Re: Redevelopment proposal at 430 W. Dayton St.

RE: Interpretation of Accessory building for project at 430 W. Dayton St.

Date: April 12, 2010
To: Plan Commission
From: Matt Tucker, Zoning Administrator
Subject: 430 W. Dayton Street

Proposed Use: Demolish existing single-family residence at rear of the lot and construct an accessory building with a five-bedroom dwelling unit.

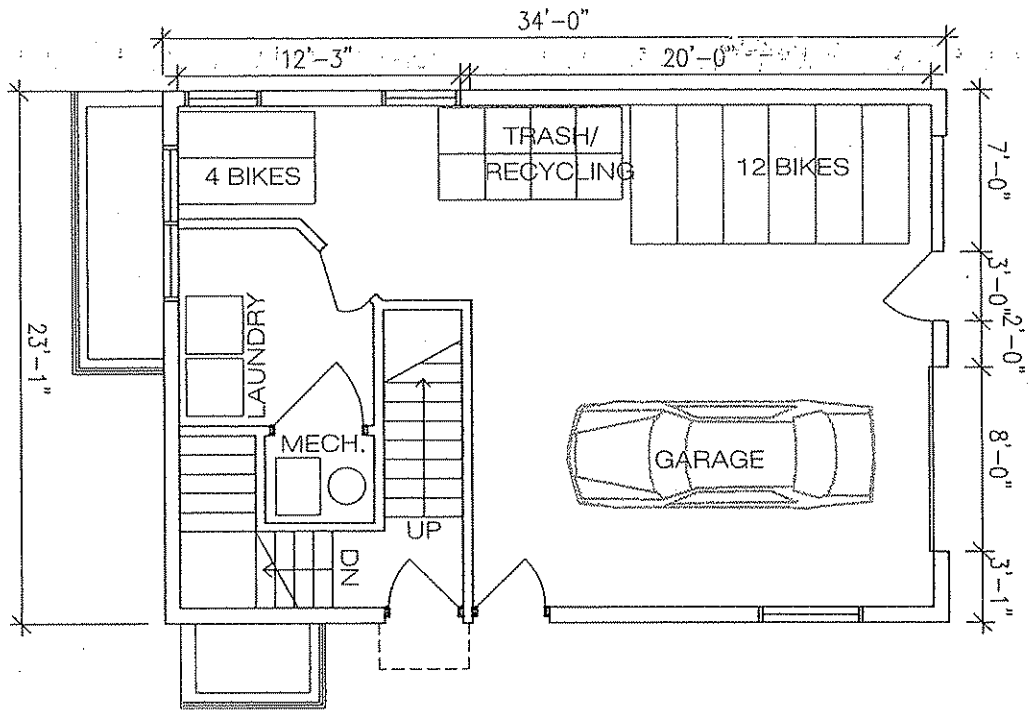
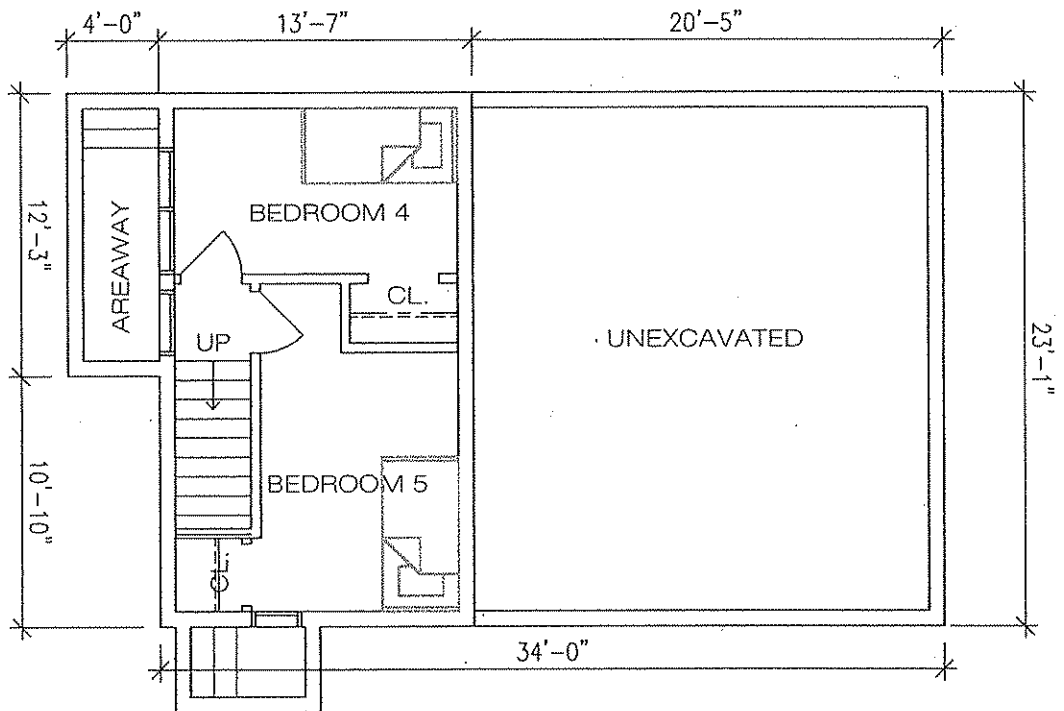
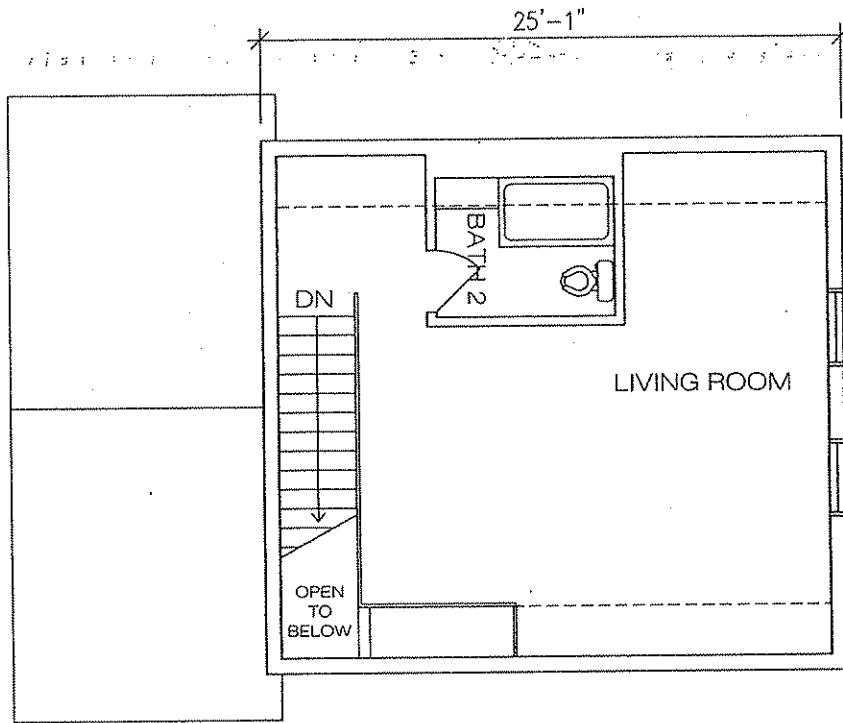
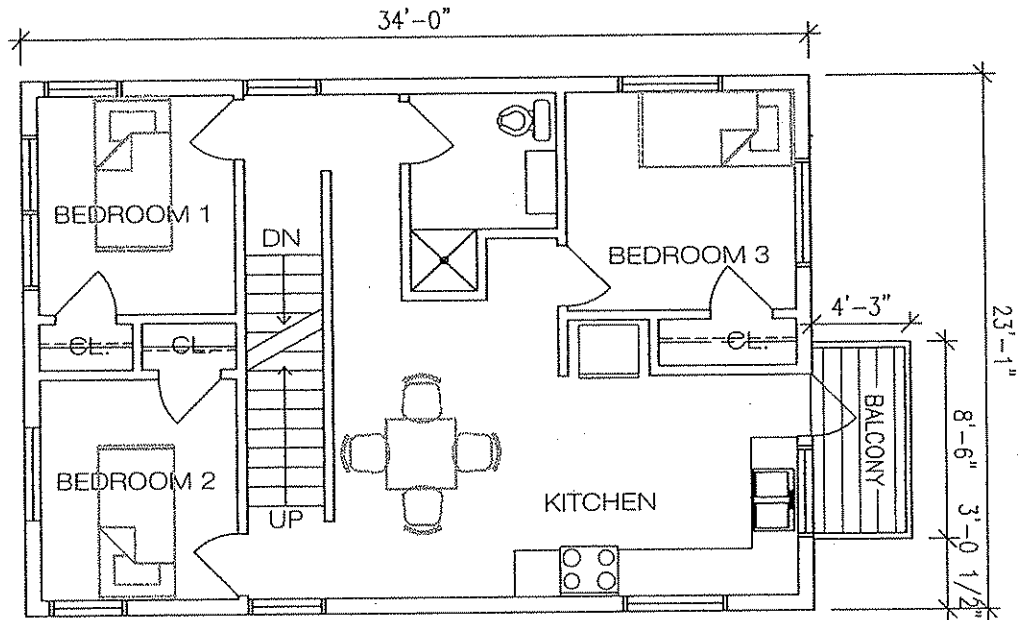
- The “accessory” use component of the structure is located on the first story (about 690 sq. ft.) of a four level structure (approx. 2,342 gross sq. ft.), which results in about 30% of the gross square footage of the structure devoted to “accessory” use.
- The dwelling unit comprises the majority of the floor area of the structure.
- The structure qualifies as a two story structure, with the dwelling unit spans four levels of the structure:
 - Two bedrooms and a half bath in the basement (1st level),
 - First floor stairwell (2nd level),
 - Three bedrooms, full bath, kitchen in second floor, deck (3rd level),
 - Living room and stair that qualify as a “loft” space in the area above the second story (4th level).

These characteristics of the project call into question if indeed the project is appropriate for approval as an accessory building, which also in turn includes a dwelling unit. The emphasis with this project appears to be based upon adding the dwelling unit first, which also includes some space to be used commonly by all occupants of the property, rather than approaching the project as an accessory building first, that also can include a dwelling unit.

The proposed project includes a single, large dwelling unit. Typically, the dwelling unit would be found on the level above a garage or storage area, with a stair for access. The size of the dwelling unit is typically limited by the size of the floor plate below. Past approval history for this type of building has shown that accessory buildings that contain dwelling units typically are comprised of first story garage/accessory space, with dwelling space added to the second level of the structure, either under gabled roof or as a full second story.

It is not clear that the project represents consistency with the purpose and intent of the zoning code, and what was intended for allowing accessory buildings to be built in this circumstance, which may in turn include dwelling units. Through all phases of pre-planning between the applicant and staff, these concerns have been raised, and the applicant was made aware of the unusual nature of the proposal should they choose to move ahead with the project as the submitted plans reflect.
